Citizens' Initiative for Manchester Affordable Housing

CIMA respectfully urges MassHousing to deny the request by Strategic Land Ventures (SLV) for a Project Eligibility Letter (PEL) for a site at O School Street in Manchester, MA because the project as proposed is inconsistent with the Town's needs, presents significant safety issues for its residents, and creates serious and substantial environmental risks.

**Subject: Traffic Impacts Peer Review Initial Findings Letter  
Sanctuary at Manchester by the Sea, MA 40B Development**

### **Reference: The Sanctuary at Manchester-By-The-Sea Concerns and Questions**

Site Driveway at School Street – Sight Distance

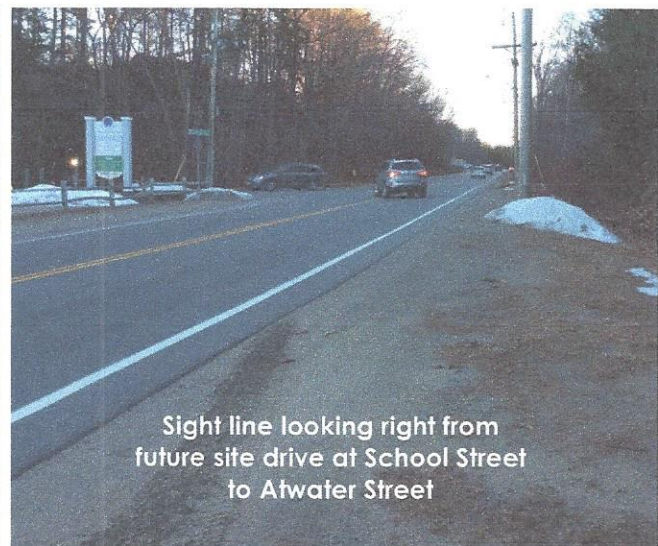
The TIA found acceptable sight lines at the future intersection of the Sanctuary at MBTS driveway with School Street. Our on-site observations confirmed the acceptability of the sight line information as presented in the TIA.

TIA estimates of the required minimum stopping and intersection sight distances between 360 and 500 feet are acceptable and are exceeded in both directions of School Street for greater than a 45 mile per hour speed of approaching traffic.

PARKING LEVEL PLAN

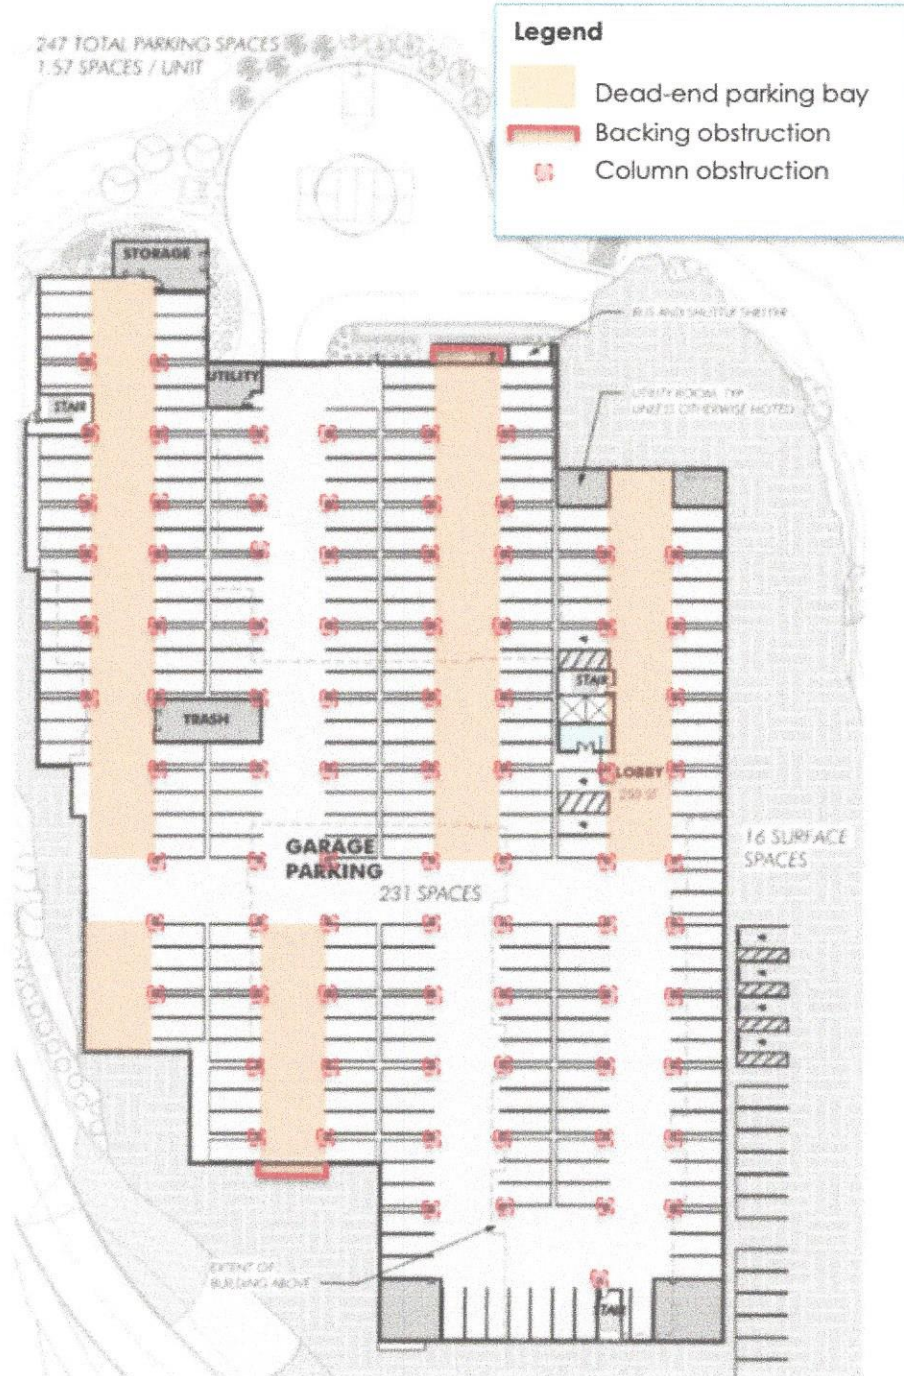
Augmented by an illustration on the next page, comments below pertain to circulation issues that warrant some discussion with the Applicant for safe garage operations, in order of importance:

- **Dead-end parking bays.** The site plan proposes a total of five 'dead-end' parking bays. Such dead-end bays are problematic and are not recommended. It is not always possible to see whether a space is occupied at the entrance to a dead end parking bay, even if all spaces are assigned to individual units. Additionally, if for any reason, an emergency vehicle must enter the garage, the absence of driving continuity could present a hazardous circulation condition.

- **Backing obstructions.** At least four parking spaces are located too close to walls for safe backing maneuvers. If possible, an indent of at least 6 feet should be considered to create a backing area for vehicles when exiting the spaces in question. We note that this issue is eliminated if there are no 'dead-end' parking bays.

- **Structural columns.** While not always practical to do so, it is best to minimize the use of structural columns in garages because they create safety hazards for users adjacent to them and a high incidence of 'fender-benders'. It is necessary to add some additional clearance areas around structural columns for the safety of motorists driving into or out of their spaces and walking between vehicles to or from their parking spaces, usually 2 feet additional width on each side of the column or, essentially a total envelope of 5 feet around the columns. The garage plan submitted calls for the installation of more than 80 columns that will directly affect the users of approximately 160 of the 231 parking spaces in the garage. The envelope around the columns seems to be 2 feet rather than 5 feet in width.

EXHIBIT II

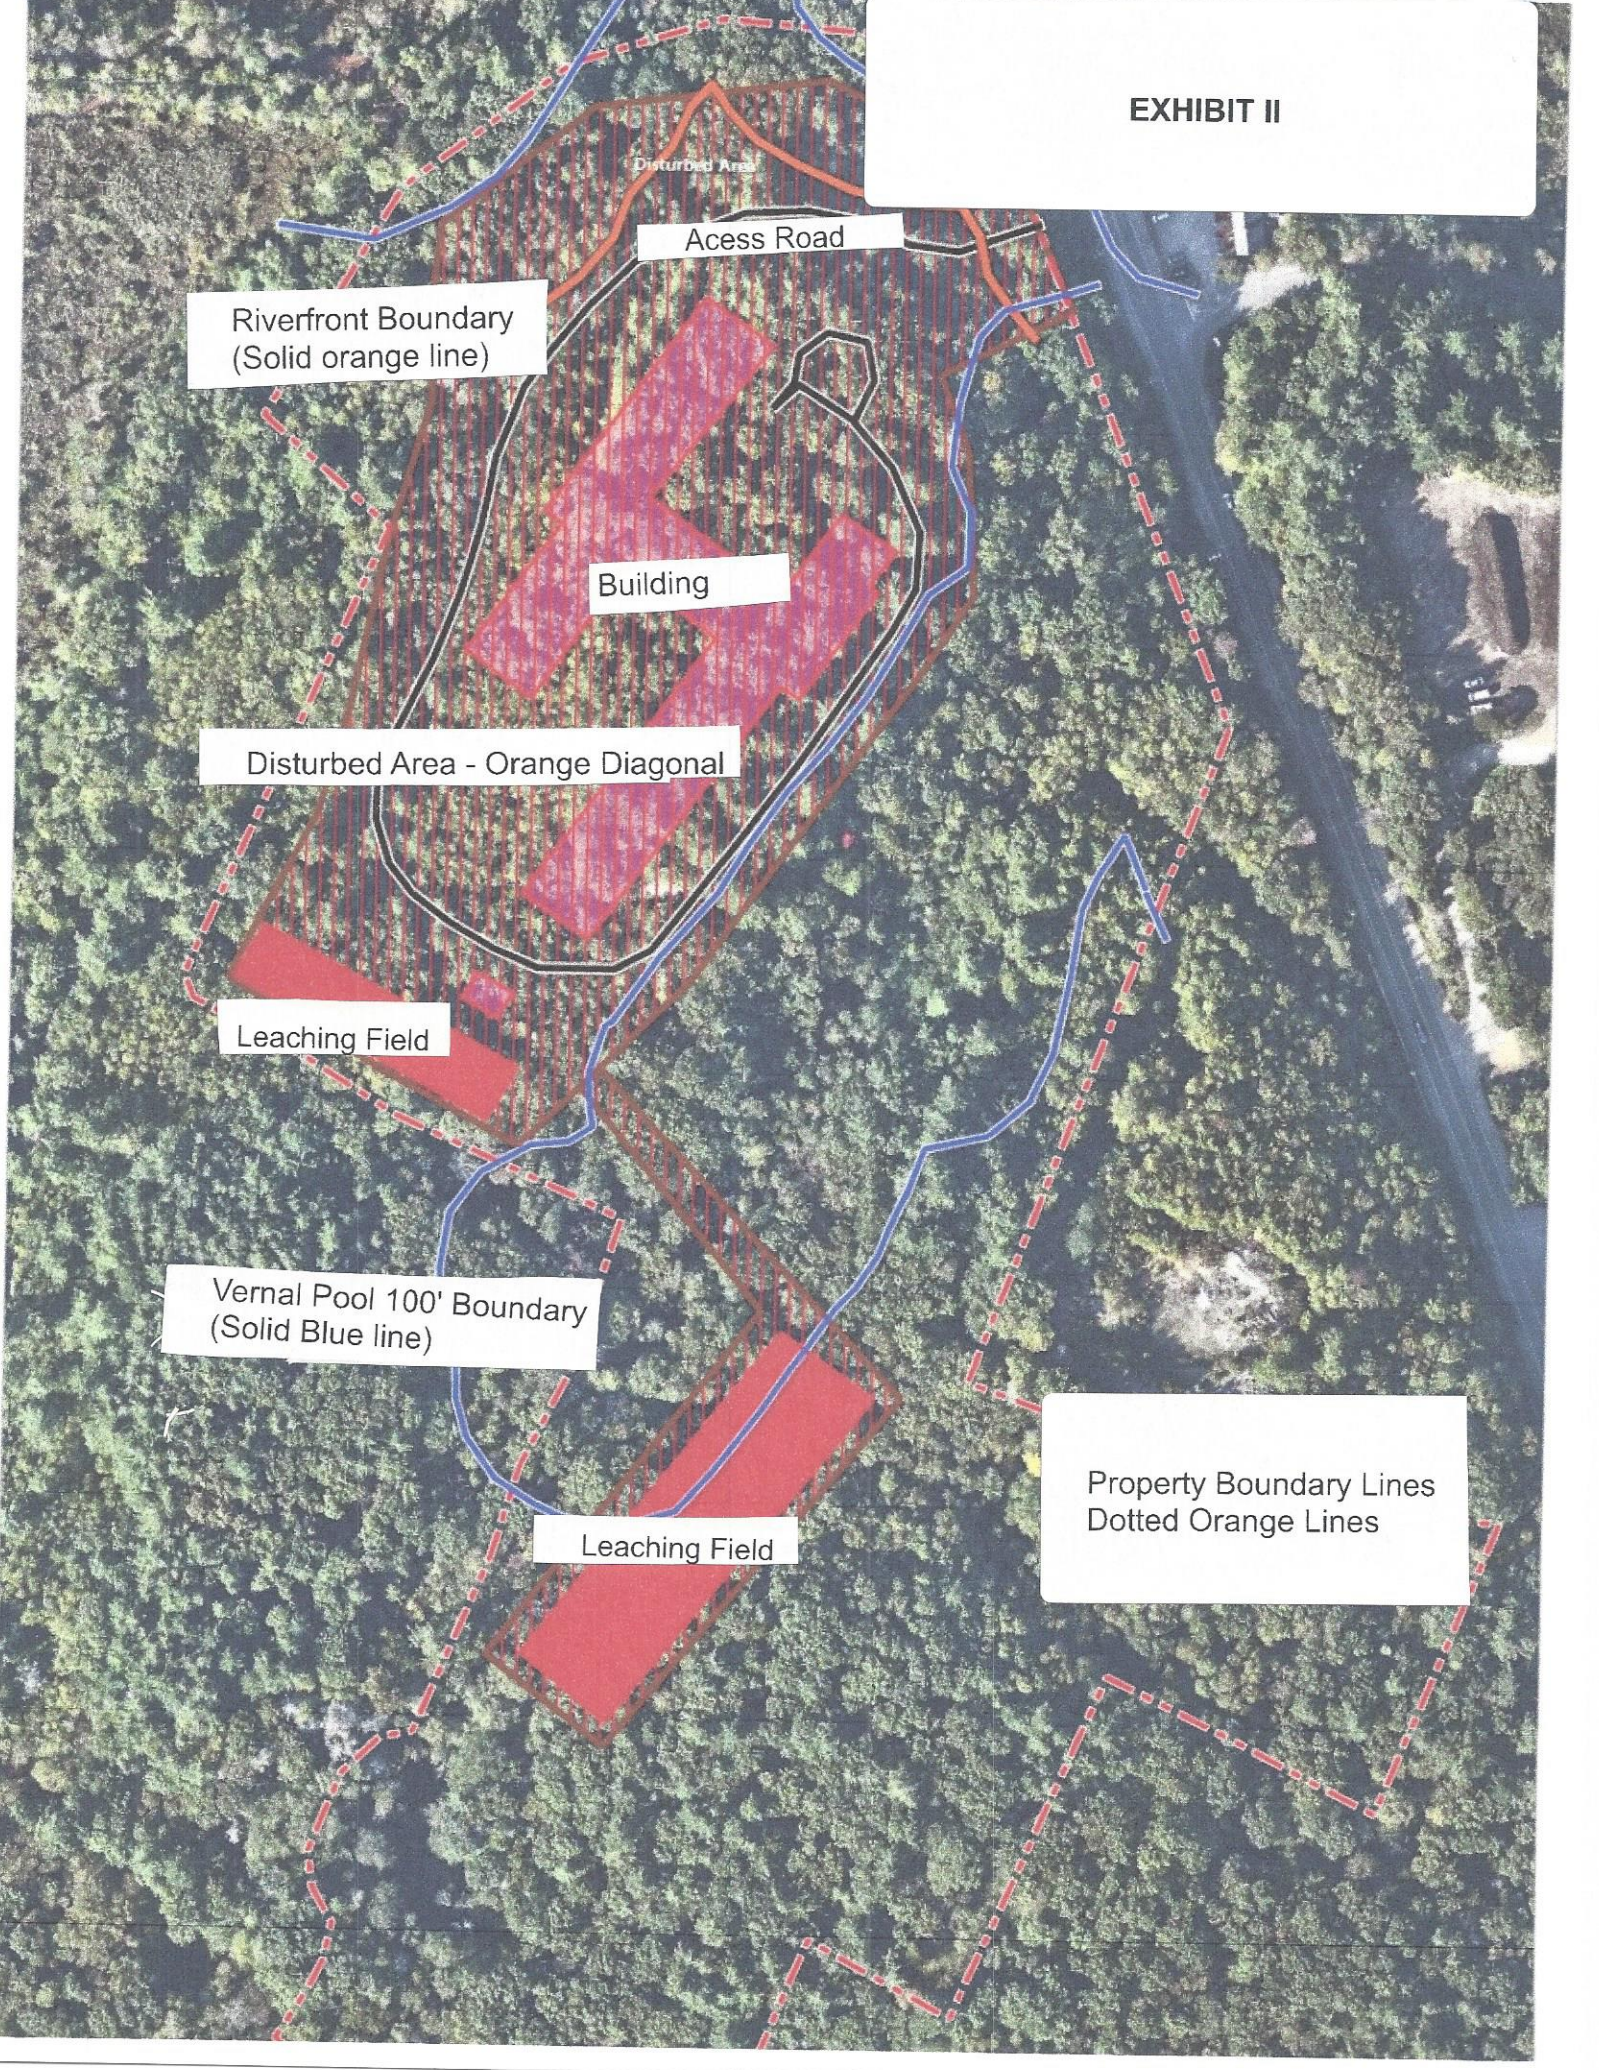
- The subject site is surrounded on all sides by rivers or wetlands. Storm water runoff is a major concern. During construction, site plans submitted to the Town indicate that the height of the site will be reduced by 40 feet, which can only be accomplished by blasting into the largely granite hill. After construction has been completed, much of the vegetation surrounding the buildings will have been removed. To date, no Storm Water Management Plan has been submitted to the Town for its review. The two catch basins located at the intersection of the access road and School Street, within the riverfront boundary of the Sawmill Brook, are likely insufficient to prevent runoff on to School Street and critical water resources. Please see Plu attached Satellite image with project overlay attached as Exhibit II.

- The proponent has proposed an on-site wastewater treatment plant which incorporates two leaching fields that appear to be on granite outcroppings with poor percolation characteristics. The leaching fields are connected to the treatment plant by a pipe which runs through an existing wetland.
